City of Round Rock

Planning and Zoning Commission

Meeting Agenda - Final

Wednesday, April 19, 2017

PRELIMINARY PLAT FOR:
THE DEPOT
TOWNHOMES SUBDIVISION
SHEET 4 OF 5

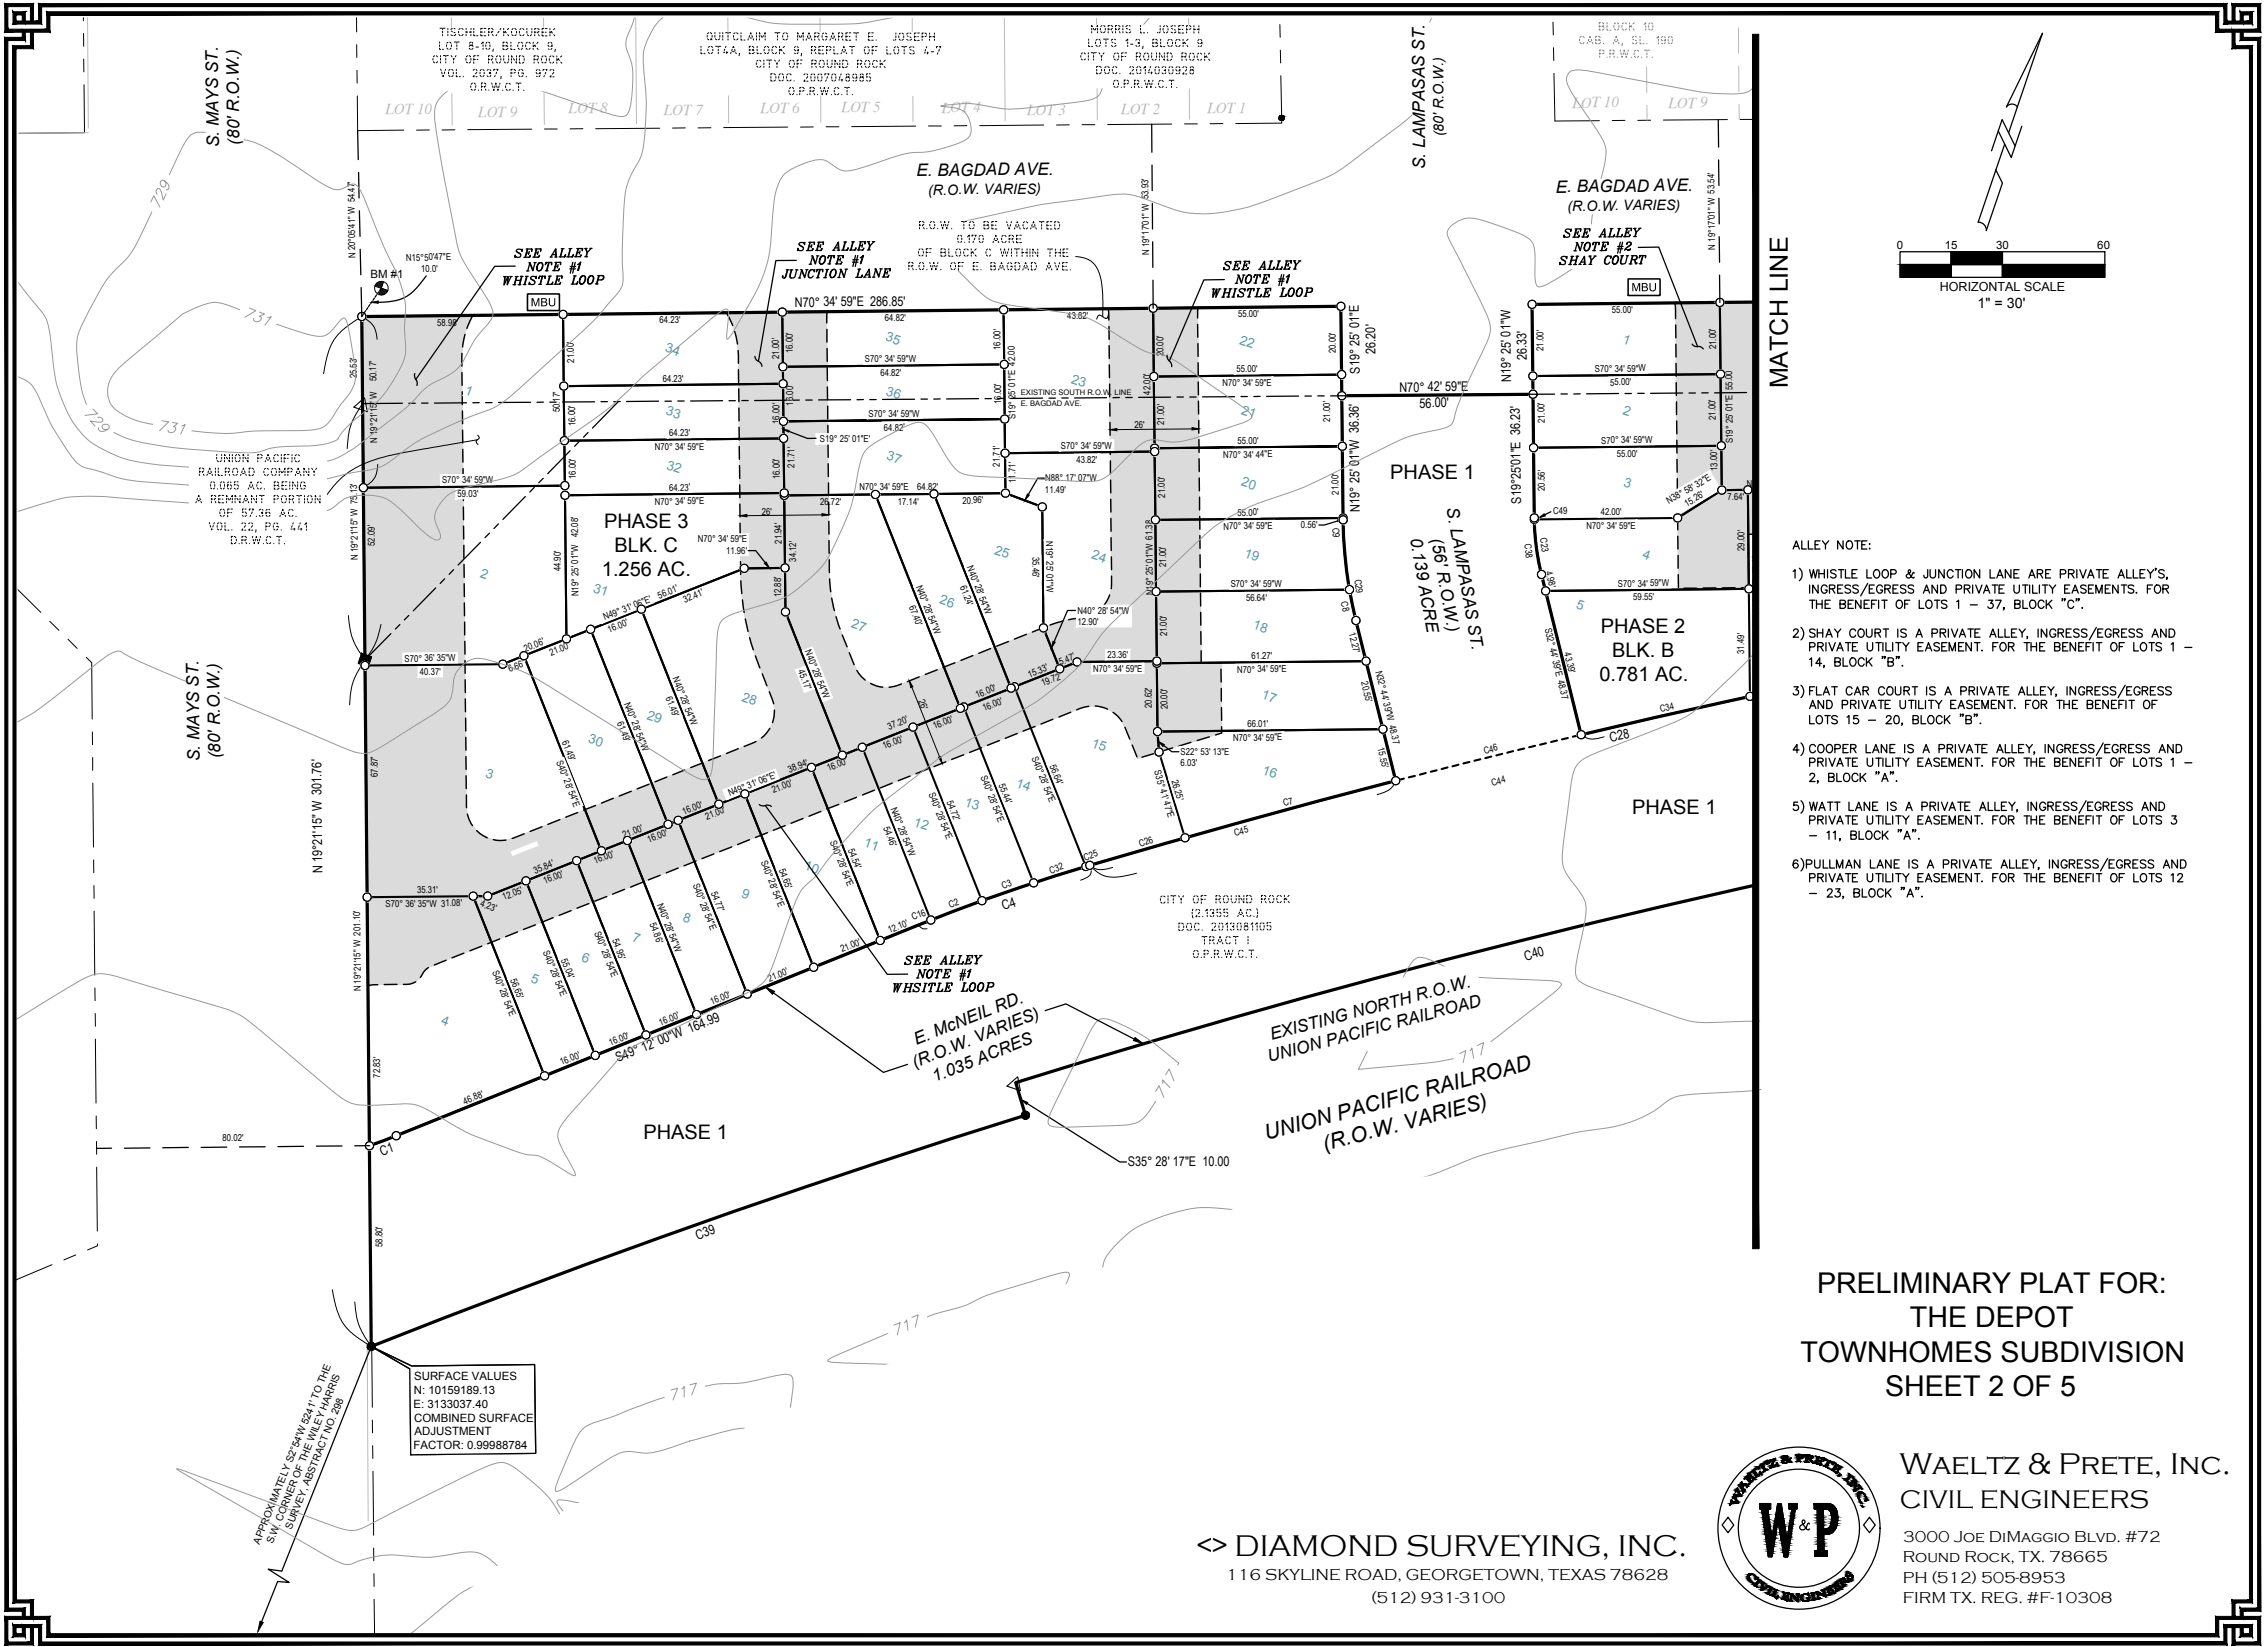
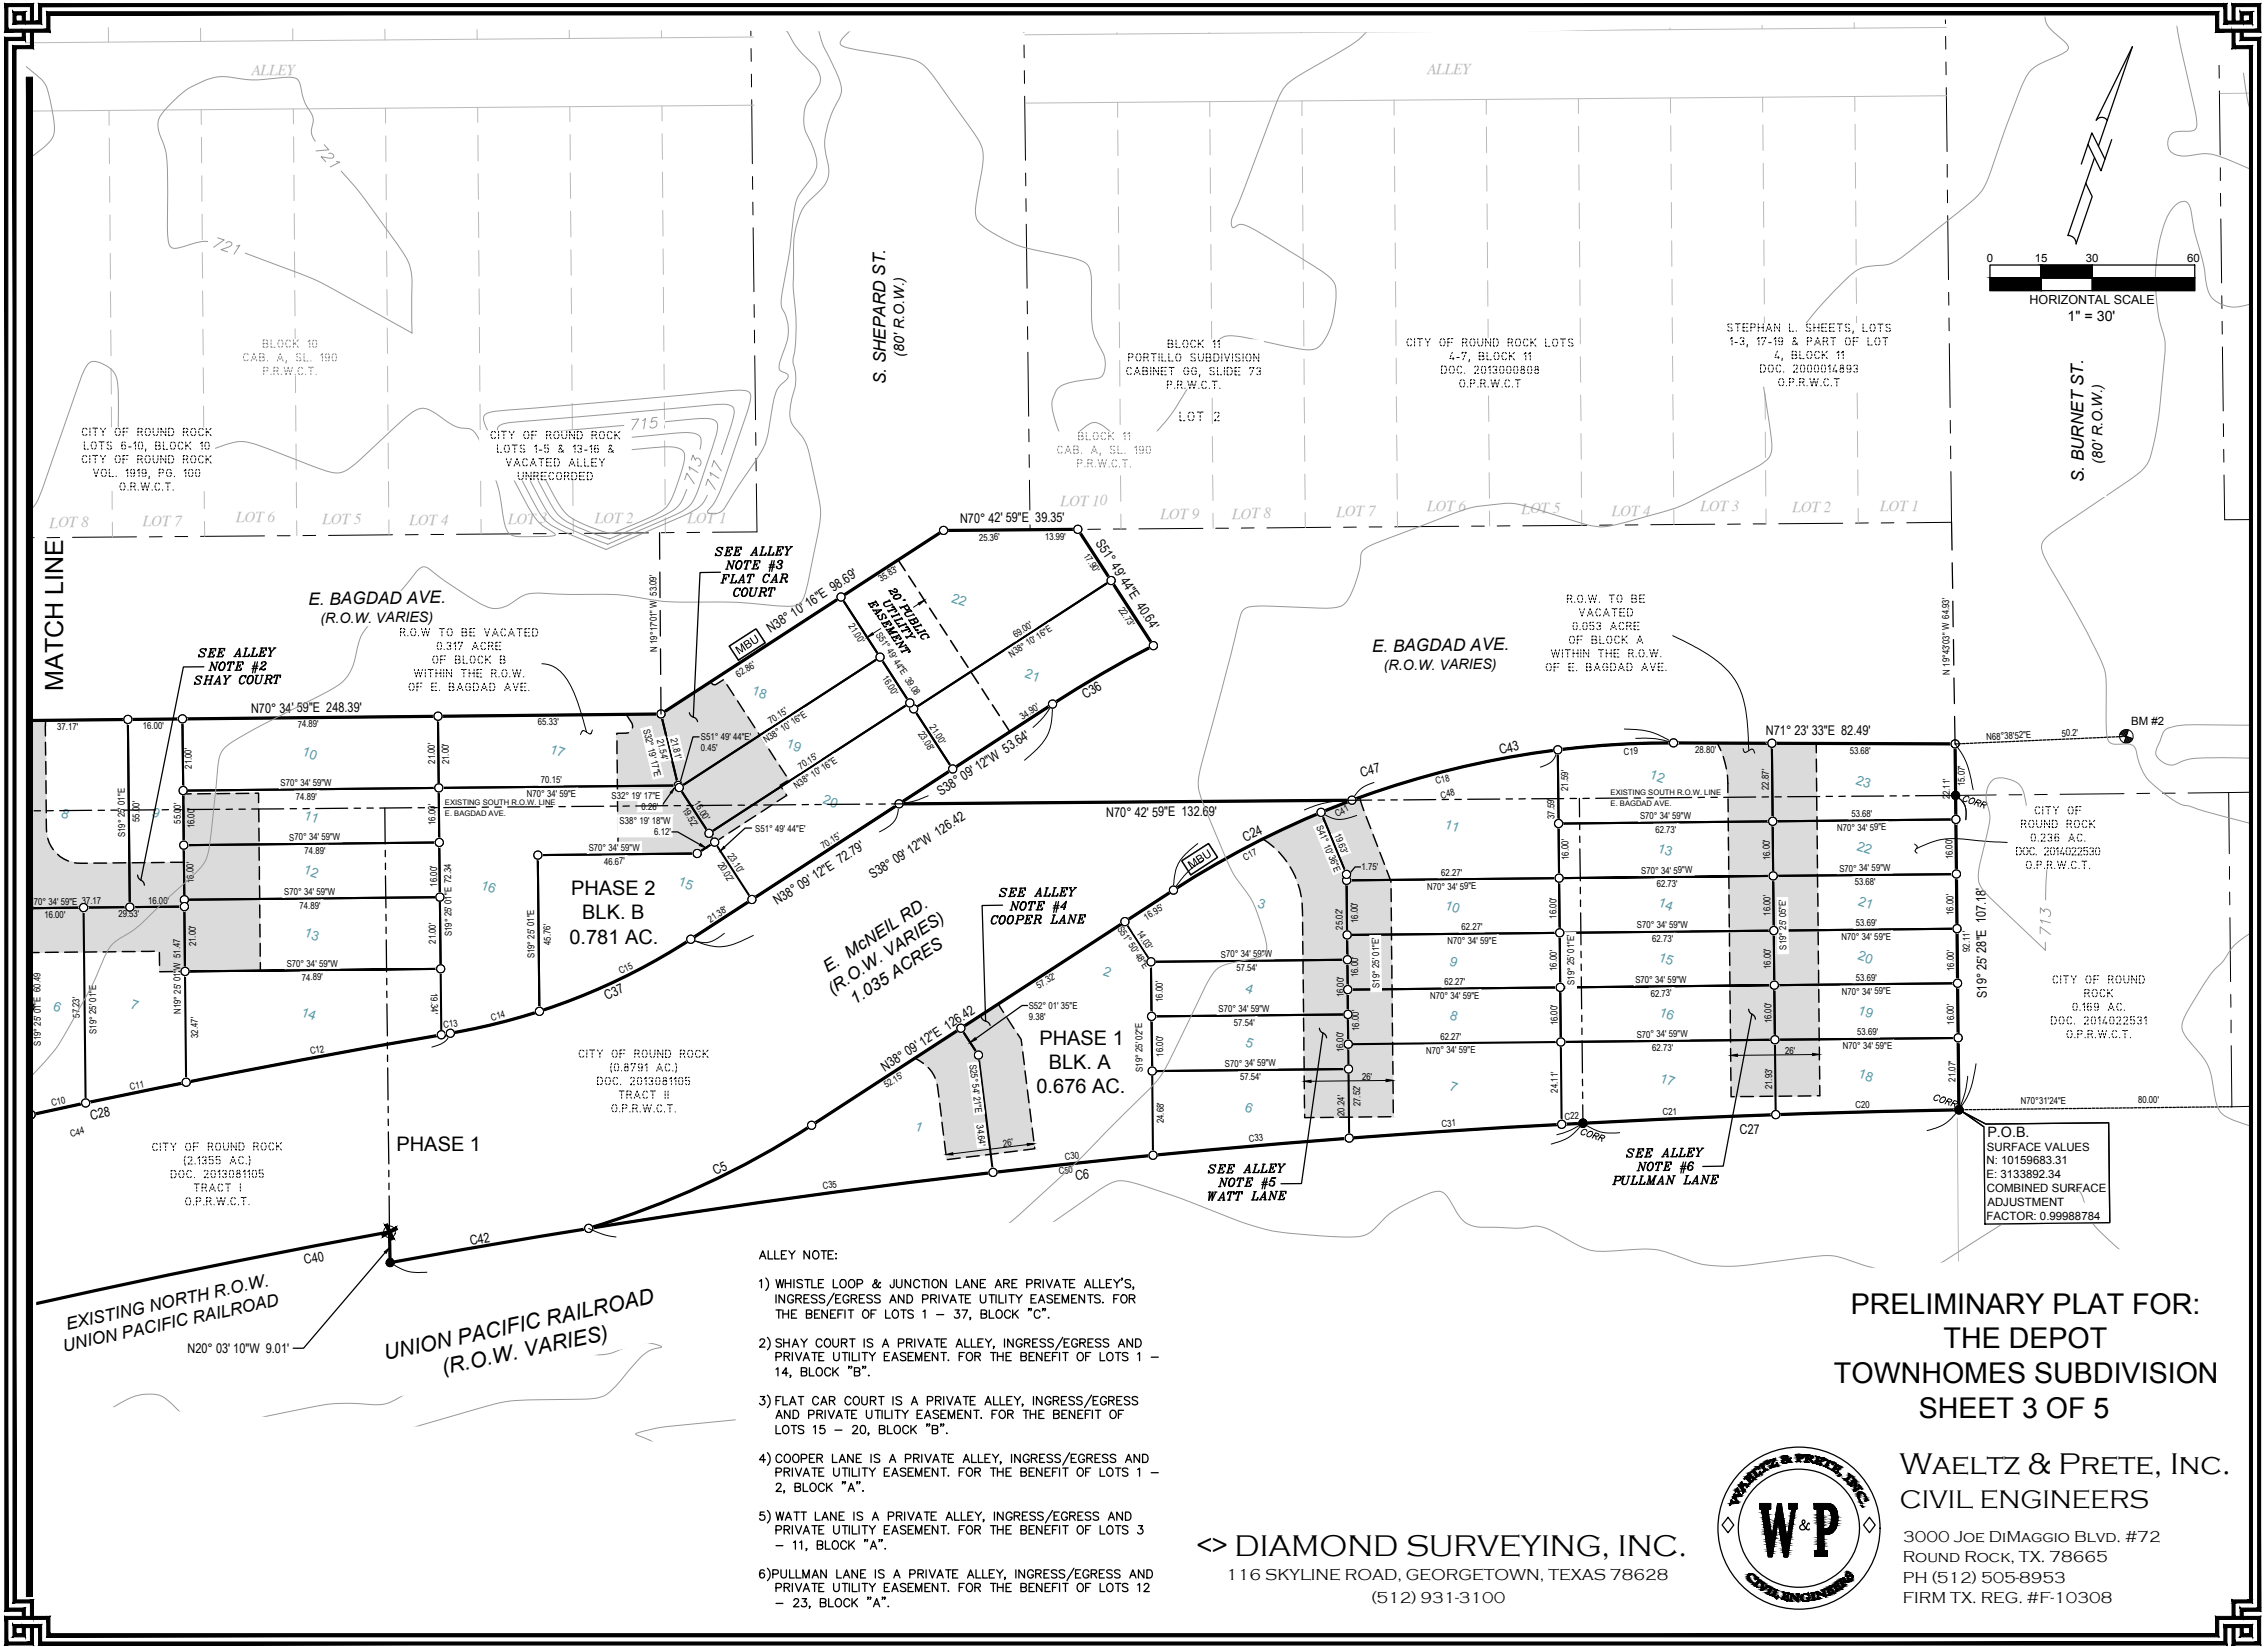
- 1) Fill in all PUD and document numbers left blank in current submittal.
- 2) Change Note # 4 to the following: With the exception of Lots 21 and 22, Block B, no unit shall take direct driveway access to any public right-of-way.
- 3) Please change suffix of all cul-de-sac alleys to "Cove" or "Court."
